Site Visit Notes – Mock-up Report

Date/Time: **January 18, 2017**
Prepared by: Scott Klingsick, KWA
Project Title: **Webster University – Interdisciplinary Science Building**
KWA Project No.: **2014-0119**
Cannon Project No.: 004561.00
Project Location: 470 East Lockwood Avenue
Webster Groves, MO 63119

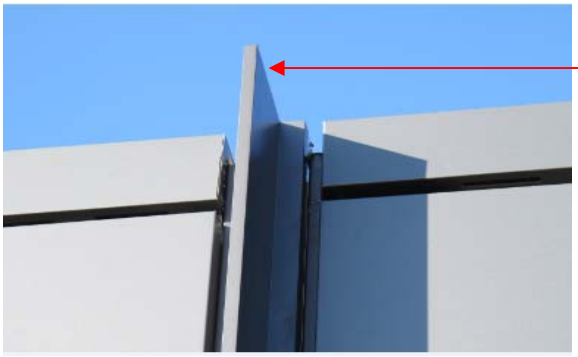
- Finish details at corners. Coping not acceptable.
- Fin/coping termination shall be in compliance with RFI 385.

Provide fin caps at top and bottom, at metal panel and curtain wall conditions.

Noted.

Noted. A sample of the fin cap has been submitted for review and response.
